# UNITED STATES PATENT AND TRADEMARK OFFICE

APPLICATION NO.	FILING DATE	FIRST NAMED INVENTOR	ATTORNEY DOCKET NO.	CONFIRMATION NO.
10/717,401	11/19/2003	Randall J. Huebner	ACM 354	7508

<b>Office Action Summary</b>	Application No.	Applicant(s)	
	10/717,401	HUEBNER ET AL.	
	Examiner	Art Unit	
	Anu Ramana	3733

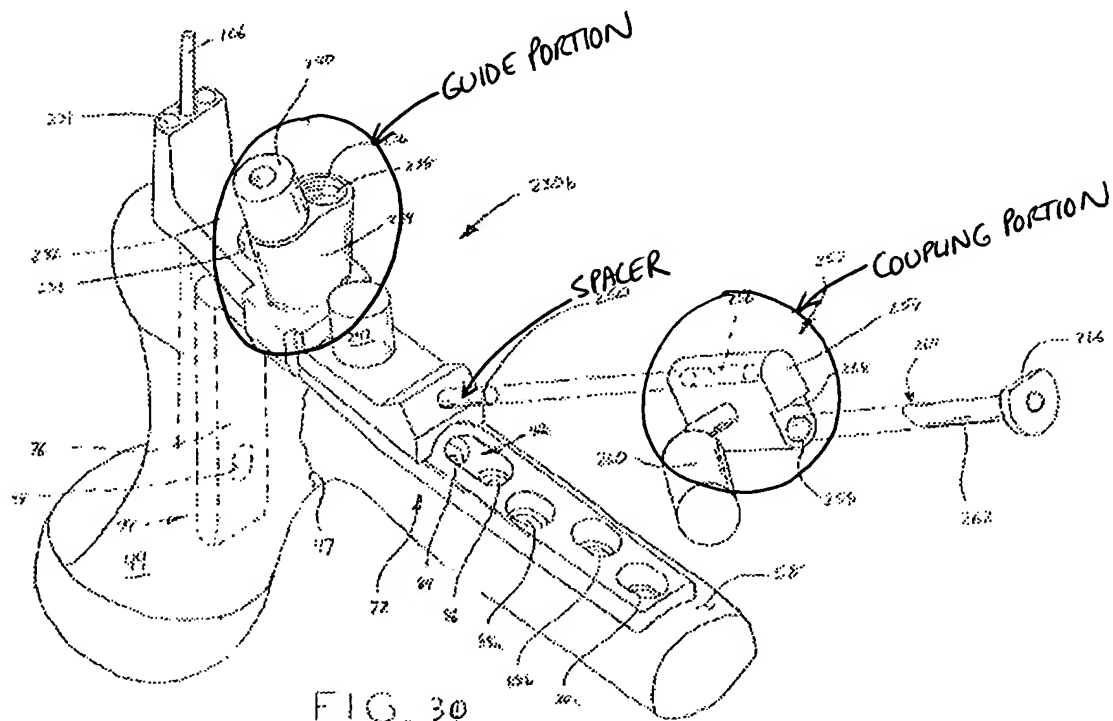
Claims 1, 4, 7-8, 10-15, 18-22, 24, 28 and 30-31 are rejected under 35 U.S.C. 102(e) as being anticipated by Aikins et al. (US 2003/0040748).

Aikins et al. disclose a bone plate 74 with predefined positions or holes (82, 88); a guide portion 230b; a coupling portion 252 connected to the guide portion and configured to be disposed across the bone from the guide portion; a removably attached drill sleeve or cannula or guide element 240; threads or "detent mechanism" 238 in the guide portion to restrict movement of the guide element; a connective feature 98; and a spacer portion or "one additional connective feature" 250 connecting the coupling portion to the guide portion (Figs. 30-31, paras [0089]-[0092]). See marked up Figure 30 below.

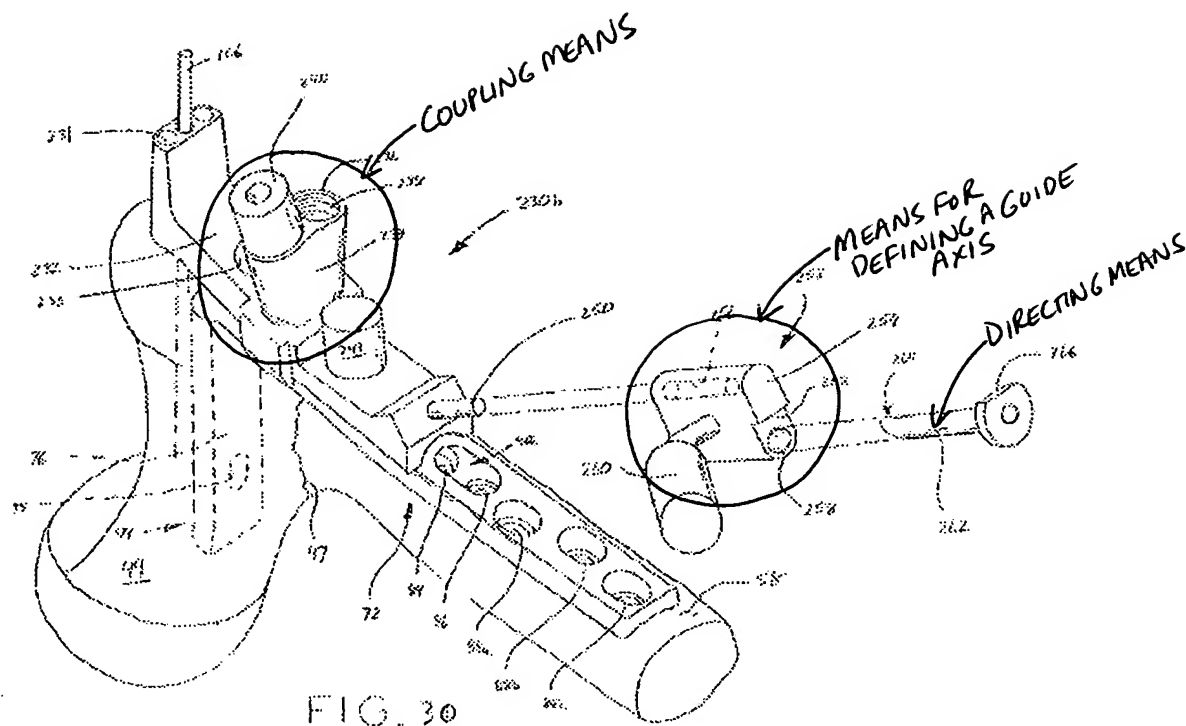
Using an alternate interpretation, claim 43 is rejected under 35 U.S.C. 102(e) as being anticipated by Aikins et al. (US 2003/0040748).

Aikins et al. disclose a bone plate 74; means for coupling to the bone plate; a means for defining a guide axis that extends through the bone (252); a means for directing a bone screw through the bone and into an opening 98 in the bone plate (Figs. 30-31, paras [0089]-[0092]). See marked up Figure 30 on the following page.

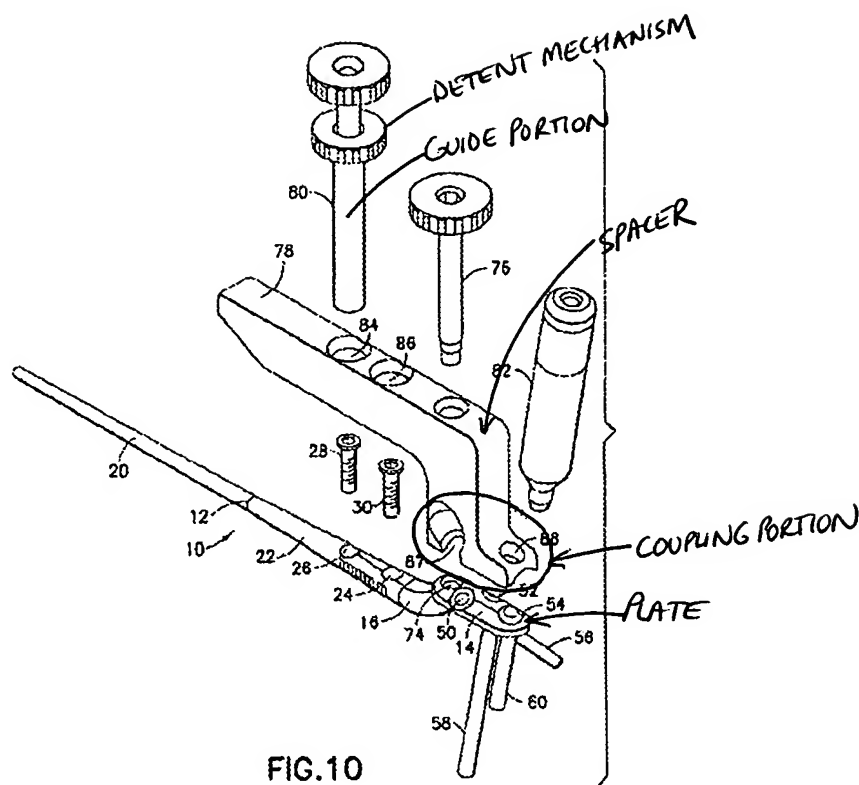
Claims 1, 5-8, 10-24, 27-28, 29-31 and 43 are rejected under 35 U.S.C. 102(e) as being anticipated by Orbay et al. (US 6,706,046).

Orbay et al. disclose a device including: a coupling portion connected to a bone plate; a guide portion 80 connected to the coupling portion and configured to be disposed across the bone from the coupling portion; a plurality of connective features (24, 26, 74); and a spacer portion (Fig. 10, col. 4, lines 58-67 and col. 5, lines 1-40). See marked up Fig. 10 on the following page.
